Project Name: Ginko Storage

Description: Final site plan approval

RE: **Ginko Self Storage -Final Site Plan/Final Engineering Plan Review-4th Review**
~~Stormwater Maintenance Agreement Review-1st Review~~

Revised Final Site Plan Review for Special Land Use for White Lake Charter Township, Michigan

ORIGINAL ISSUE DATE:
FEBRUARY 2, 2023

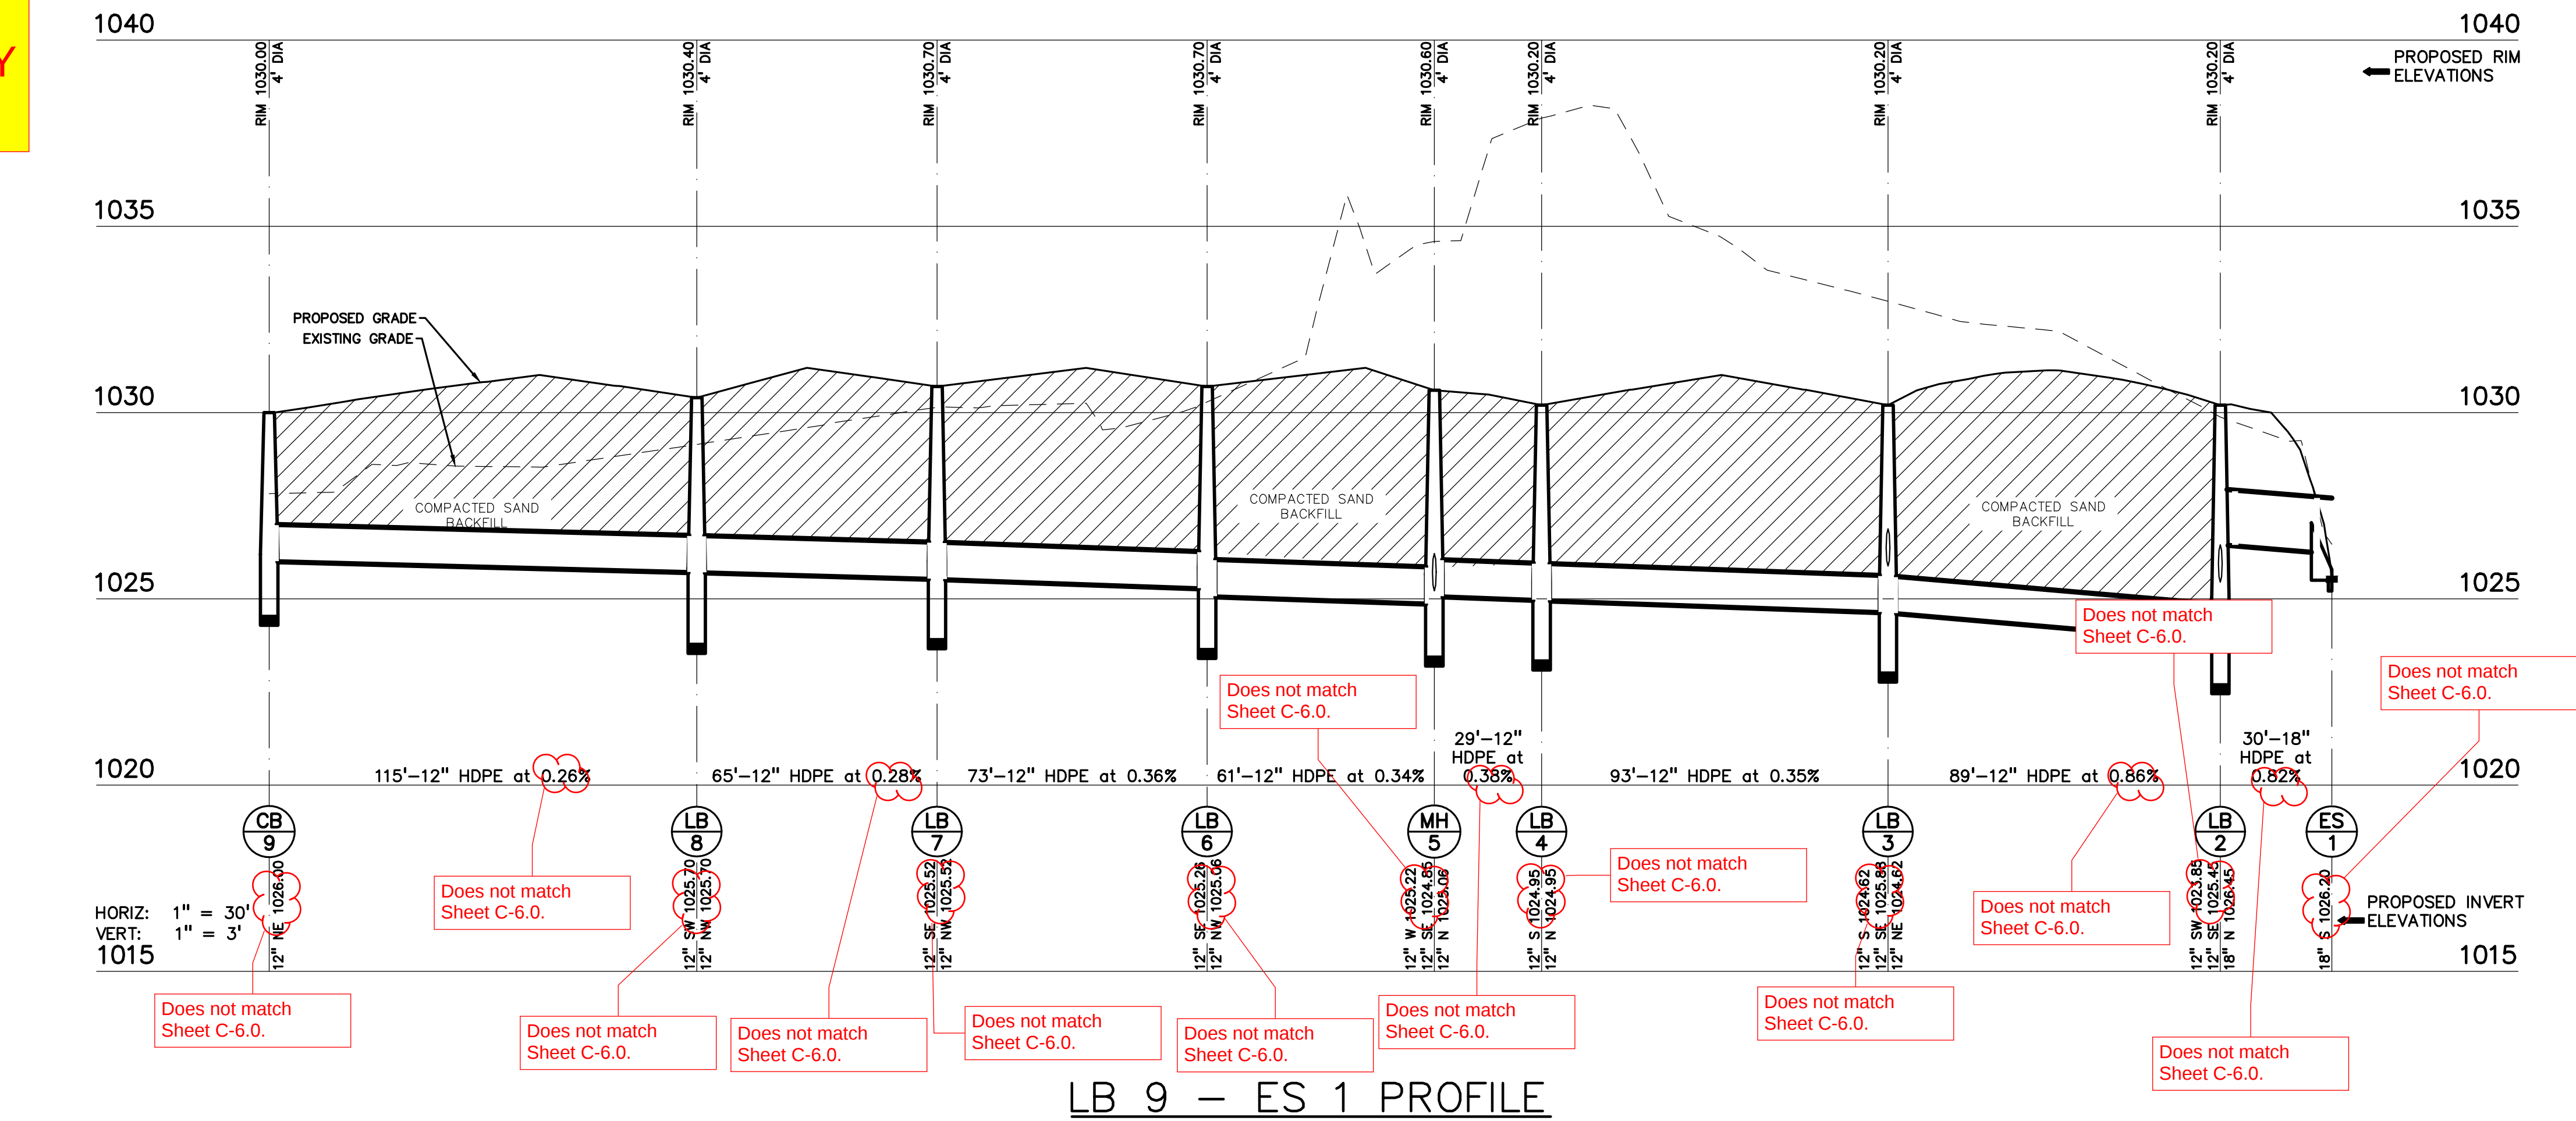
3. Sheet C-7.0- It appears that profiles were not updated based on revised storm sewer structure rim and invert elevations. We have attached a red lined copy of this sheet.

SITE PLAN

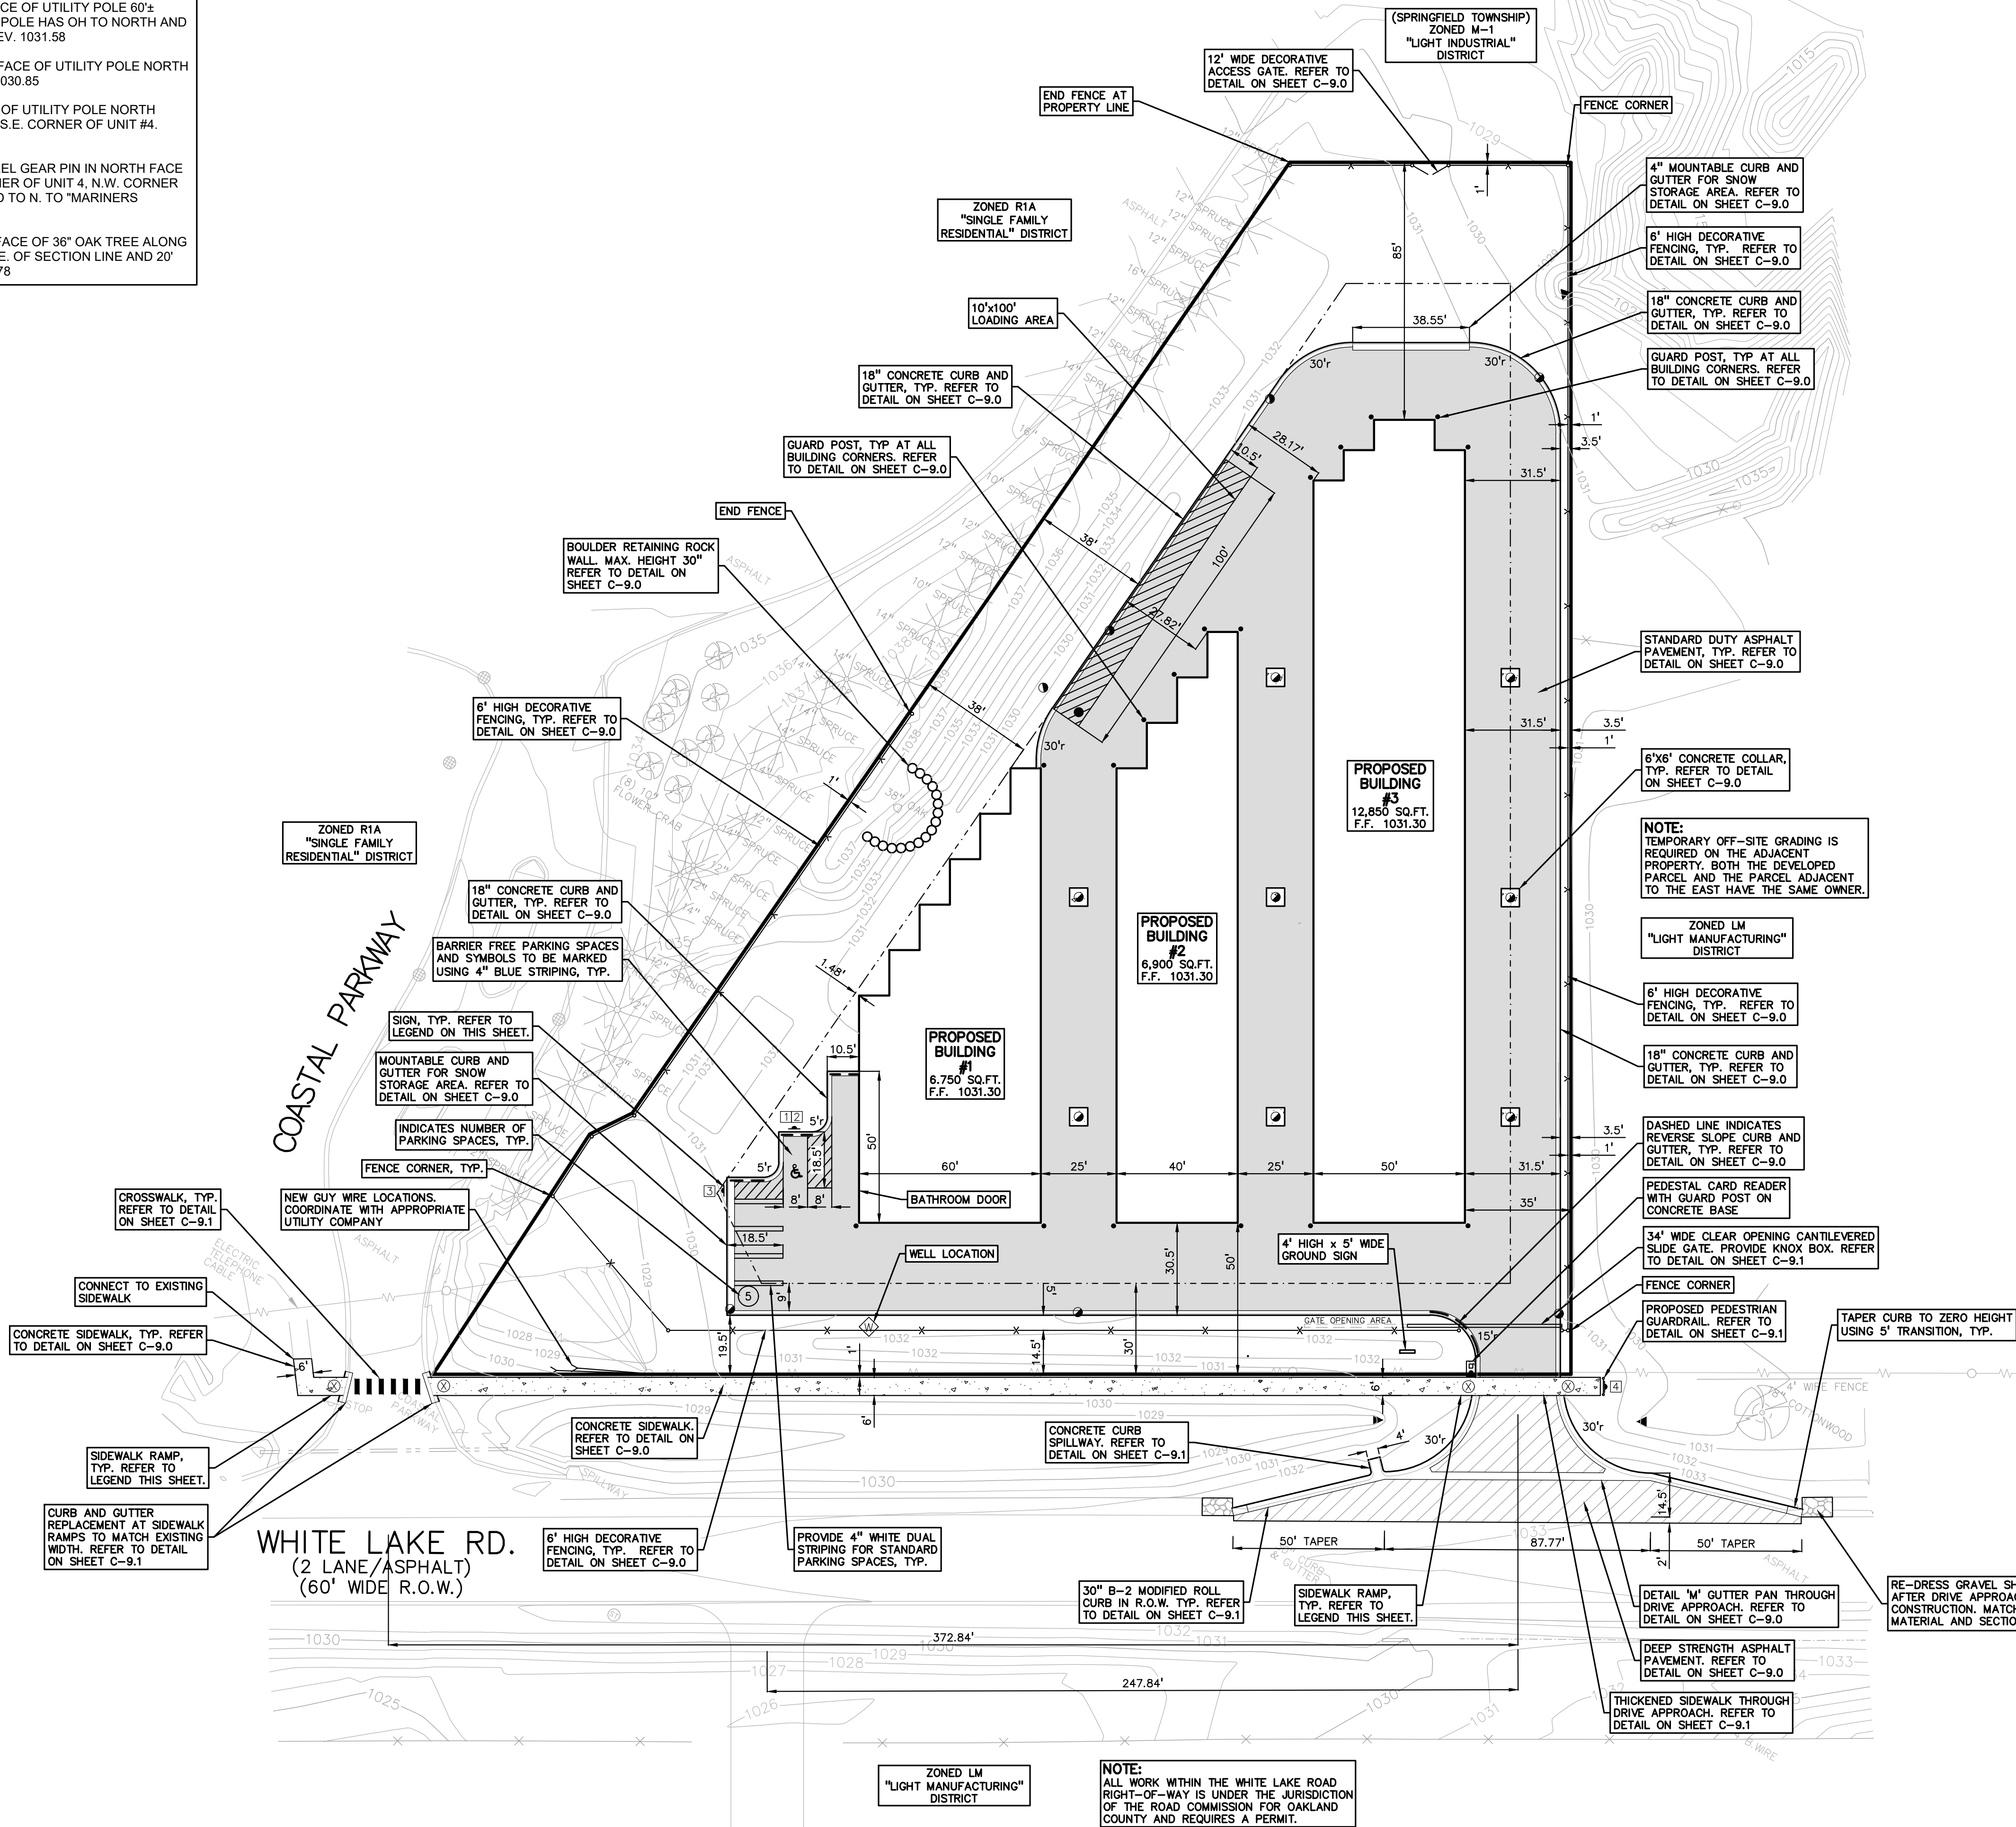
1. Sheet C-3.0- Striped crosswalk at drive entrance has now been eliminated. Is this the intent or is this in error?
2. Sheet C-4.0- Provide ADA parking blowup for this area; this was shown on the previous submittal.

We also note an access drive located on the opposite side of the road. The distance shown between these is 274 feet. This does not meet the requirement of a minimum of 350 foot distance and will require a waiver from the Planning Commission per Section 6.4.F. Final design of the access drive will require Oakland County Road Commission (RCOC) approval.

Items to be Addressed: Parking space layout will need to be modified to maintain the 20-foot landscaped buffer setback or a variance will be required from the Zoning Board of Appeals.

GRADING PLAN

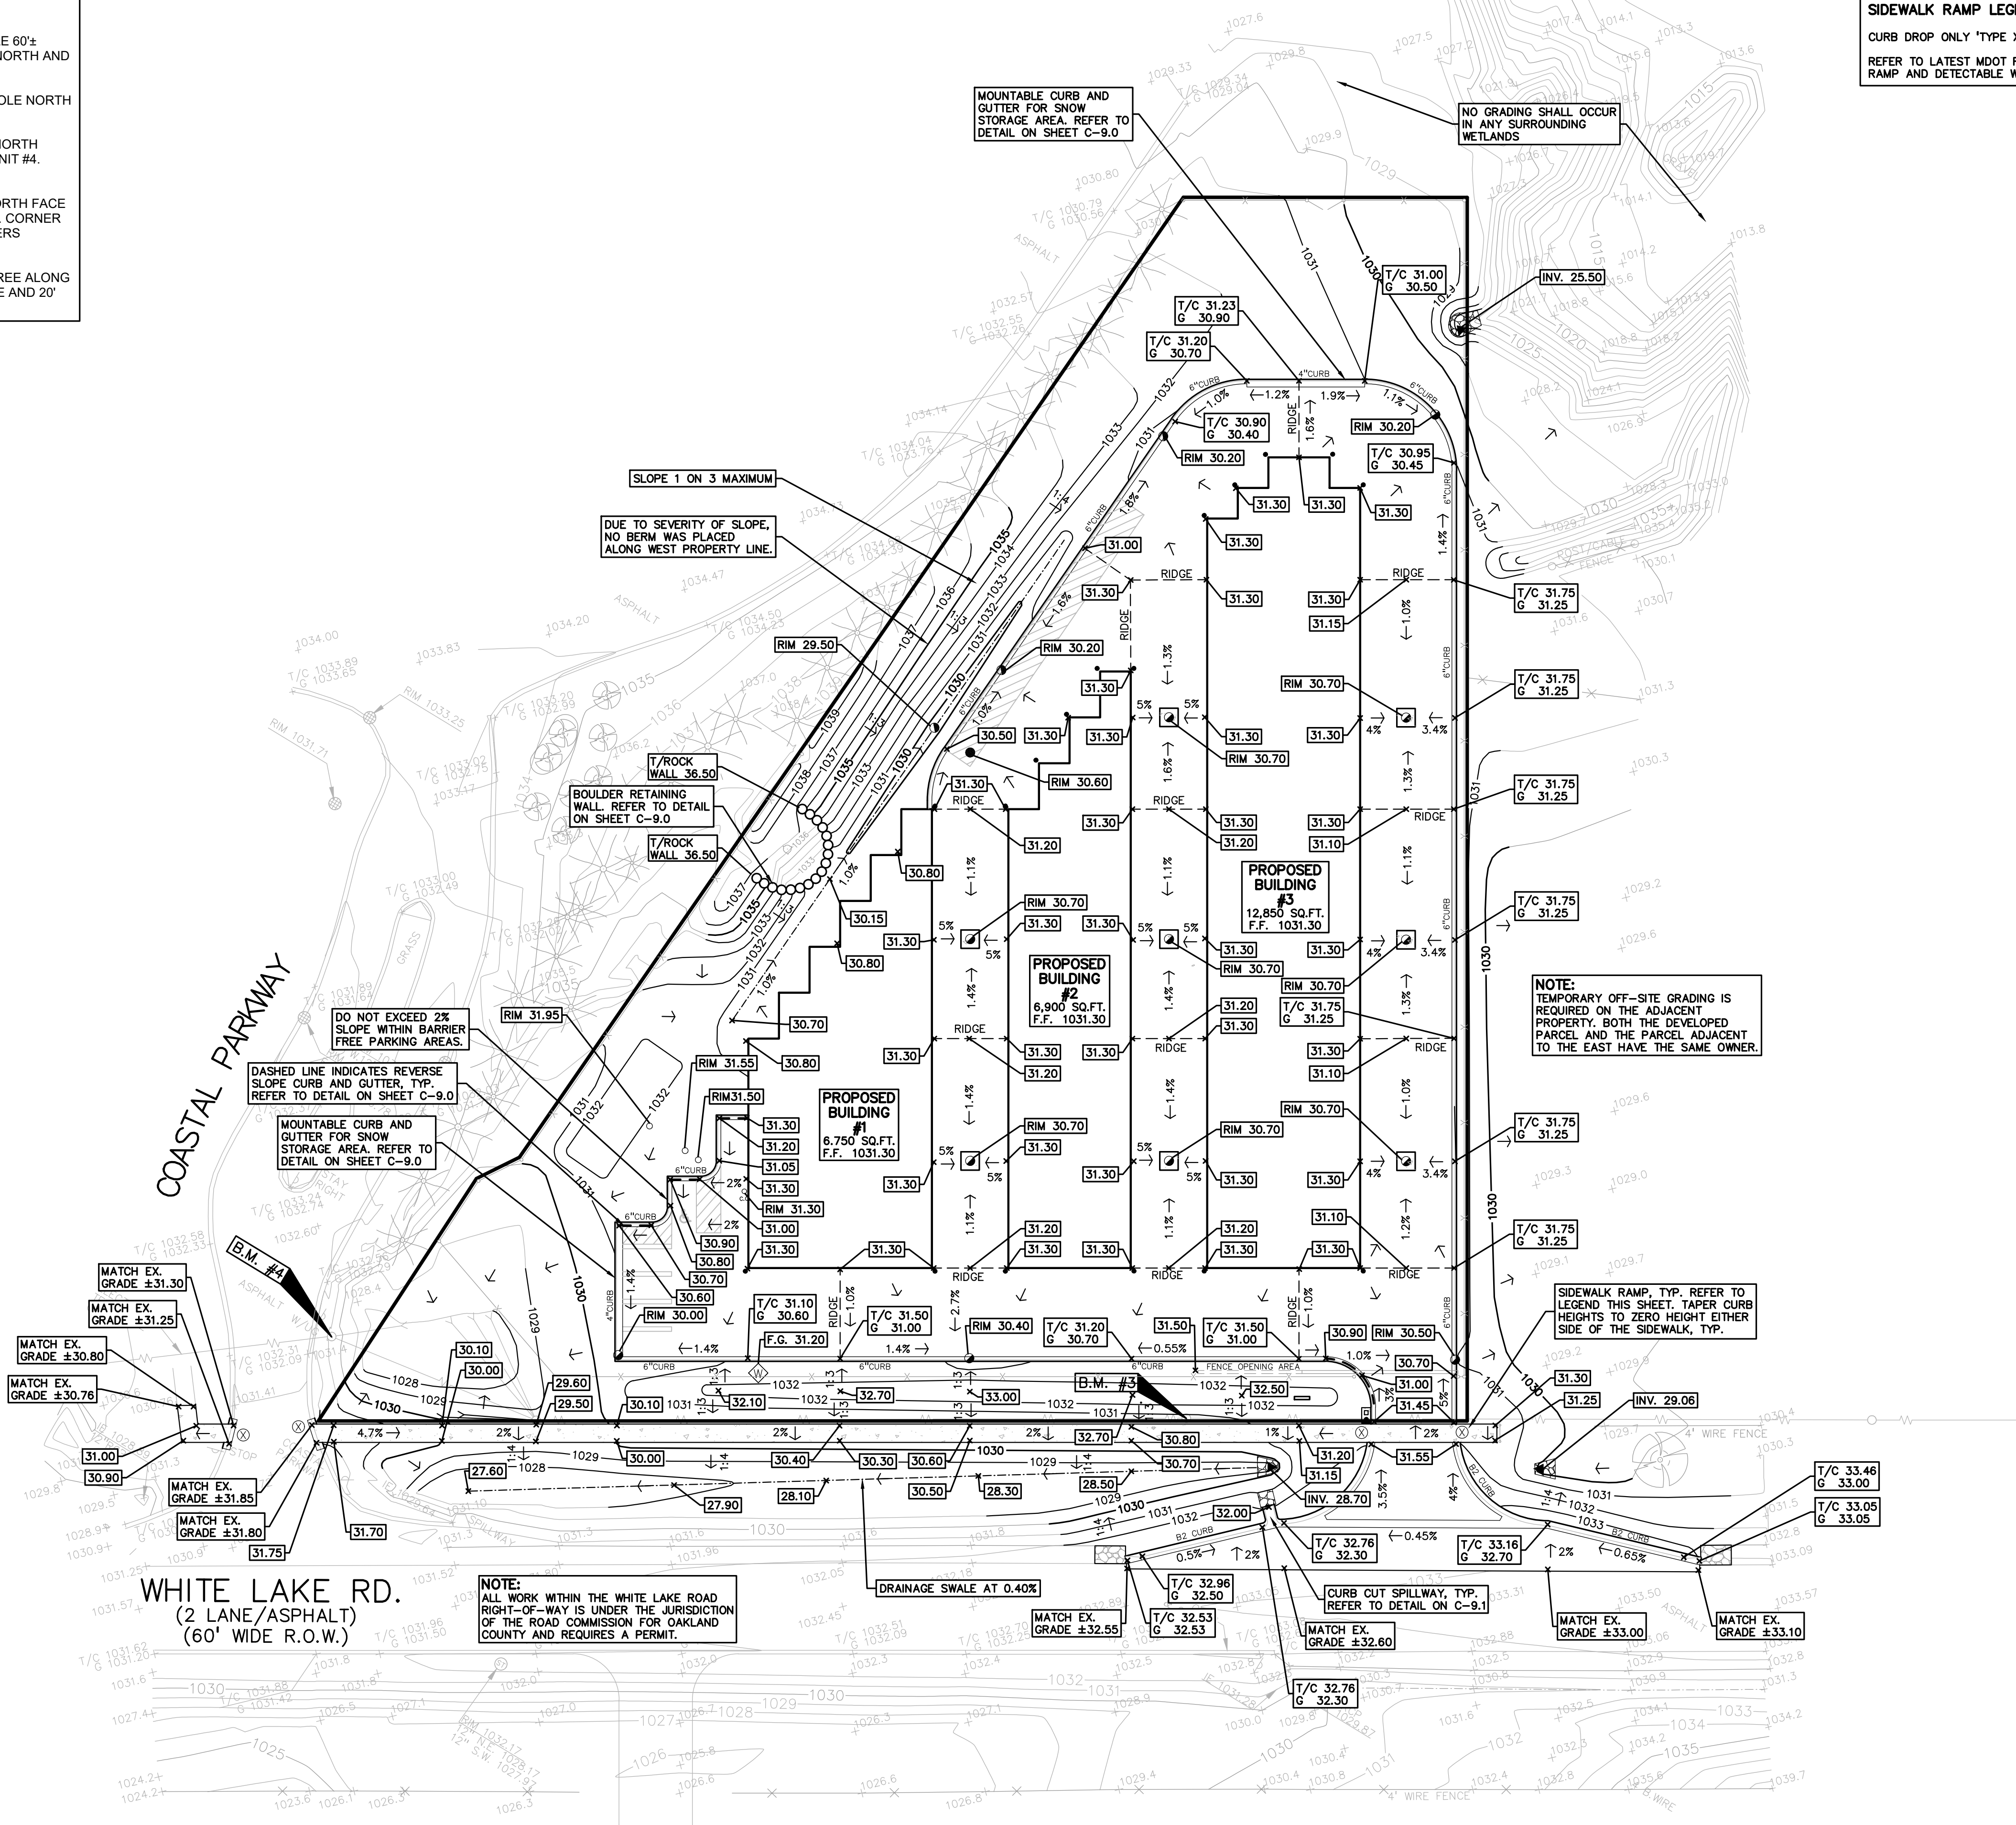
3. Sheet C-4.0- What is the top of rock wall grade on the east side toward Building #1? Previously, this was shown as 31.50'. Please clarify grade intent in this area as well as provide T/W and B/W elevations at regular intervals for wall.

4. Sheet C-4.0- SW corner of site- Drainage will collect in a hole (1028) in this area. Provide a positive outlet for drainage in this area.
5. Sheet C-4.0- Easternmost edge of sidewalk – Locations of grades 31.30 and 31.25 as well as drainage arrow seem reversed based on proposed contours to the east.

6. Sheet C-4.0-Proposed drainage swale in ROW and to the south of proposed sidewalk along White Lake Road- Drainage in this area will collect at the low point of 27.60 and will pond within the entire 1029 contour until drainage spills over at the existing 1029.64 ES invert. This will cause flooding of a portion of the proposed sidewalk (at 29.50/29.60) and could lead to spillover on the sidewalk into the 1028 on-site low point (see Comment 4 above) with additional drainage accumulating. Previous plan set showed a different grade for the existing culvert under Costal Parkway, did this change?
